A BEARING SECTION
 F2 3/4" = 1'-0"

| SHOP DRAWING REVIEW | |

| | TOWN OF BRATTLEBORO TH 12, CLASS III (LOCAL ROAD) OVER HALLADAY BROOK BRIDGE NO.: 7 PROJECT NO.: BRO 1442(35) | CHKD: M.D. DFTM: B.L. JOB NO: 23424-014 |
| | SUPERSTRUCTURE DETAILS | DWG. NO: F2 |

DATE: MAR. 24, 2014
SCALE: NOTED
CHKD: M.D. DFTM: B.L.
JOB NO: 23424-014
DWG. NO: S1

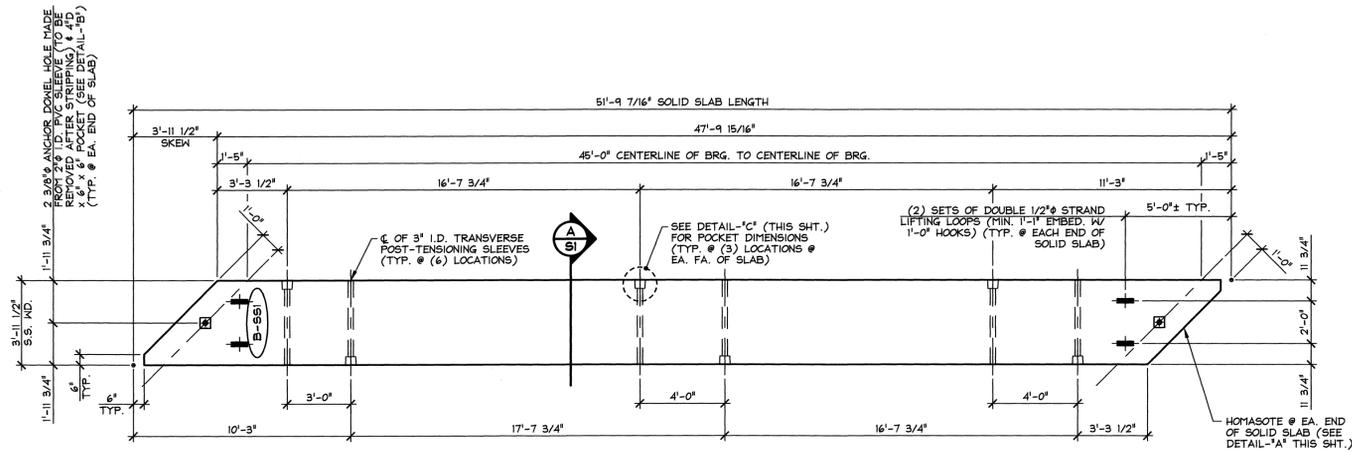
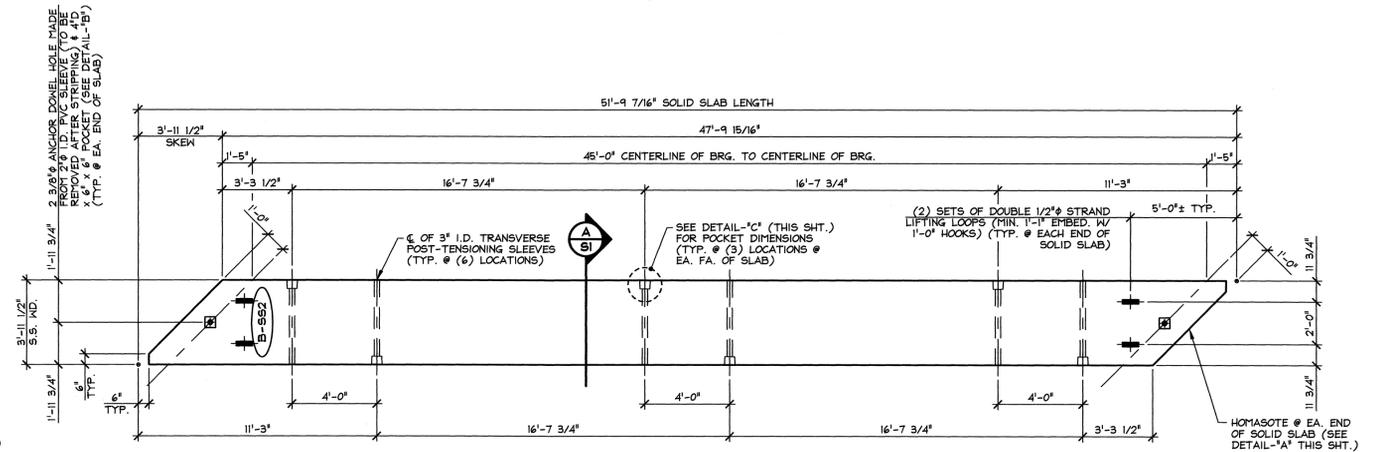
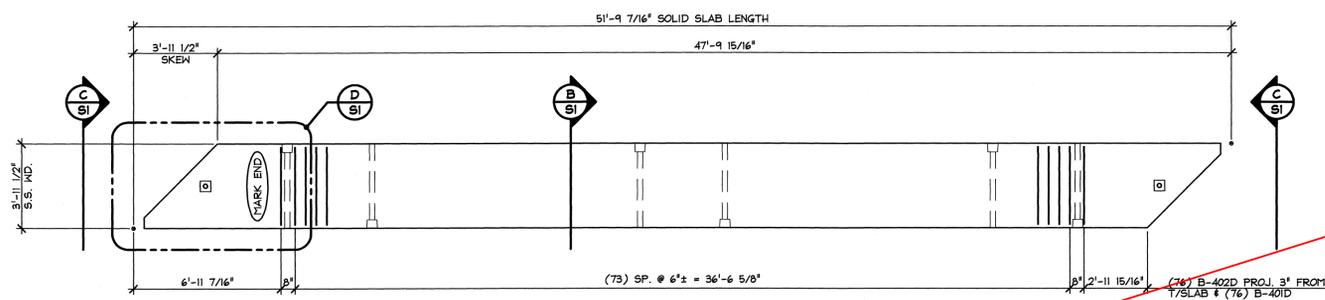
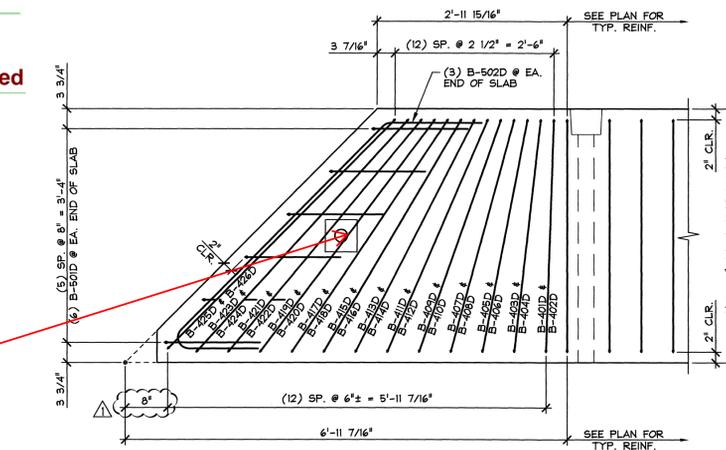
4-24-14 REVISE REINFORCING

PRESTRESSED SOLID SLAB DETAILS
DWG. NO: S2

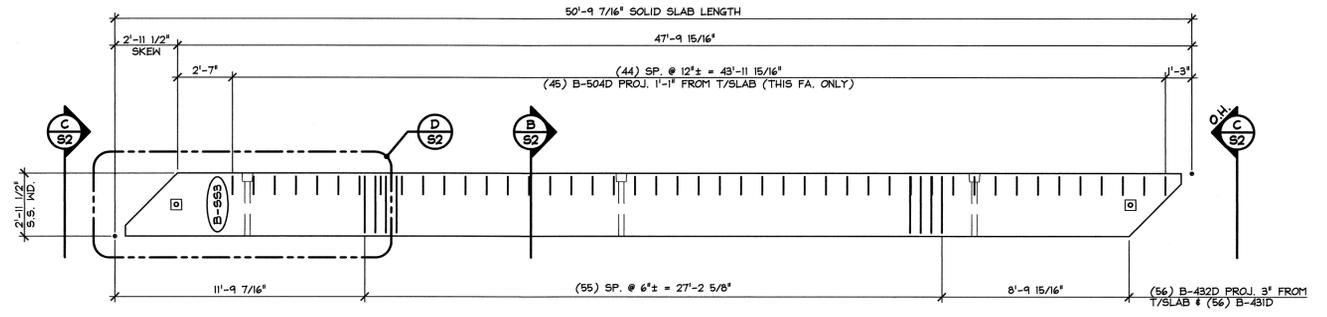
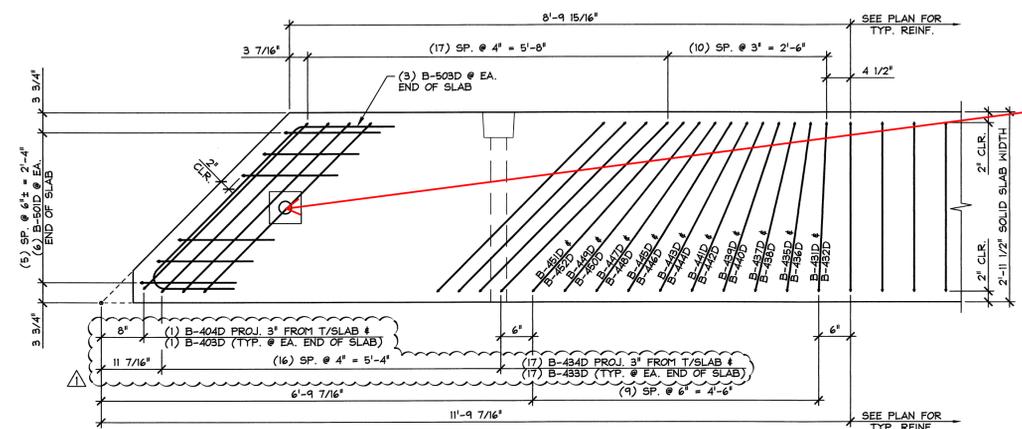
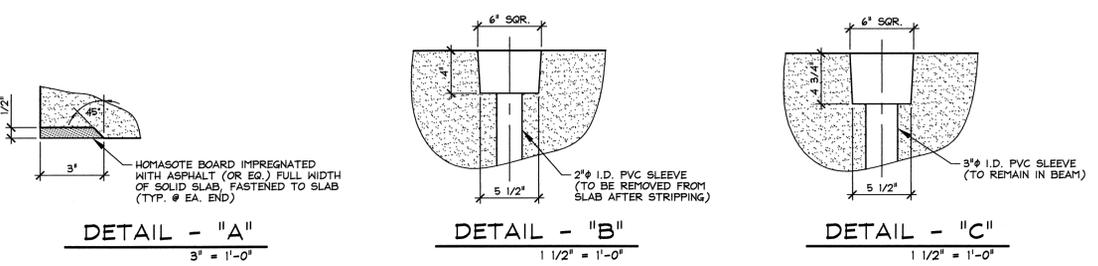
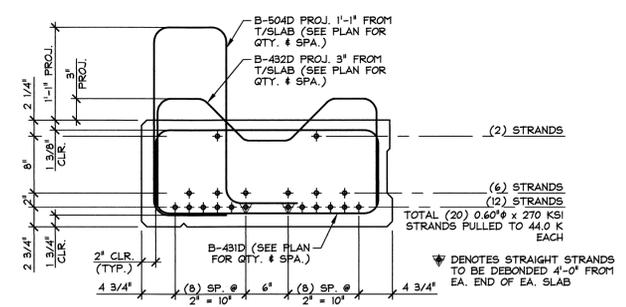
4-24-14 REVISE REINFORCING

DETAIL - "A"
3" = 1'-0"

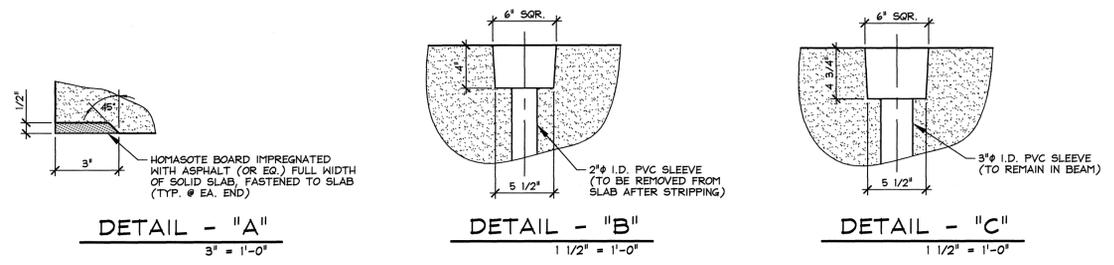
this is drawn showing interference with the post tension duct. that 6" space will be reduced to probably 4" or less. and the upper 3" spacing to the next might be 1" or slightly greater after shifting this stirrup more toward center of beam.
